County Road 28 Subdivision Preliminary Stormwater Management Report Addendum

TO: Matt Coffey, MCIP, RPP **SUBJECT:** 13-T-22-503, OPA-3-22
The County of Prince Edward and Z-43-22 – County
Road 28 Subdivision

FROM: The Greer Galloway Group **DATE:** April 18, 2024

Figure 1 - Updated Proposed Development Catchment Areas

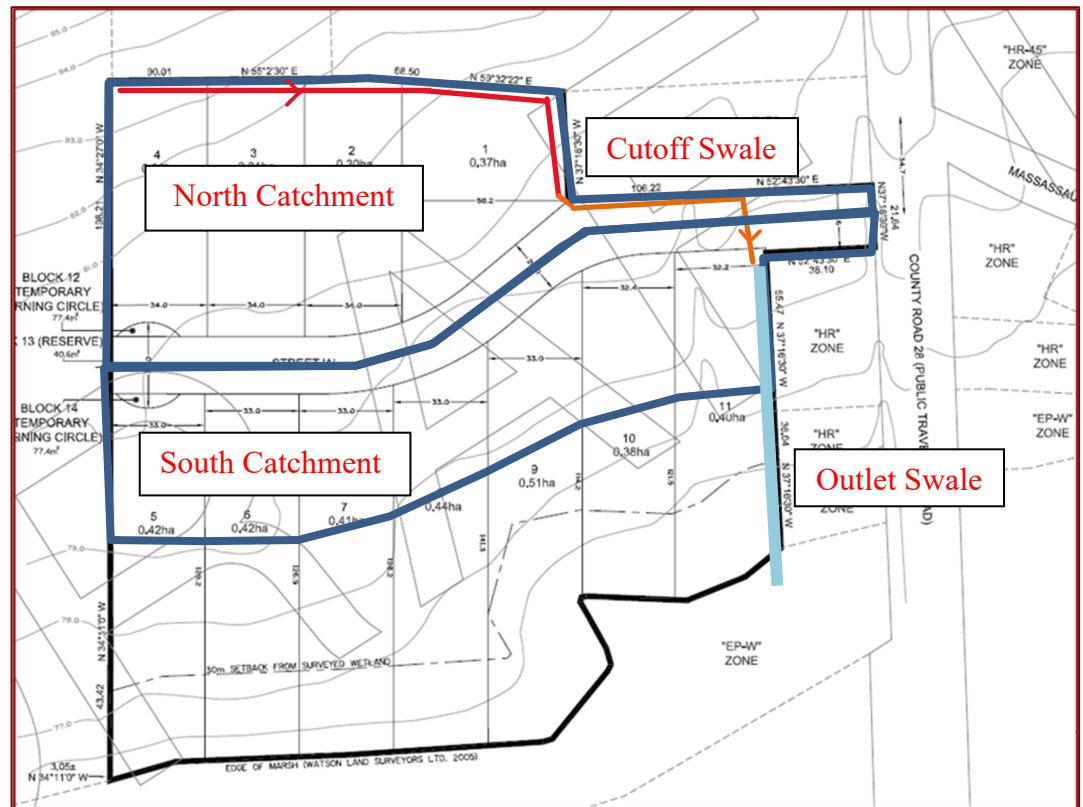
Section 3.2 notes that a cutoff swale will be constructed along the northern and eastern property boarder. Please provide a Figure of this swale. How will this swale be sized? What property will this swale be located on? Who will be responsible for maintaining this swale?

Based on further review of the report and supporting calculations. It was noted that there is a grammatical error in Section 3.2 of the report. The proposed cutoff swale in the North Catchment will be running west to east instead of east to west as noted in the report. The corrected north cutoff swale location and direction have been shown below in Figure 1. The cutoff swale in the North Catchment is to be V-shaped, with side slopes of 3H:1V, at a slope of 1.0%, depths of 0.25 m, and a top width of 1.50 m.

The cutoff swale will be located at the Northern/rear yard limits of lots 1, 2, 3, and 4 run South along lot 4's side yard where it will outlet into the roadside ditch and ultimately make its way to the outlet swale via a culvert. The envisioned location of the swale can be found in the above Figure 1.

The length of the swale that falls within the limits of the lot is to be maintained by the owner of the individual lot. The length of the swale which falls in the ROW is to be maintained by the County.
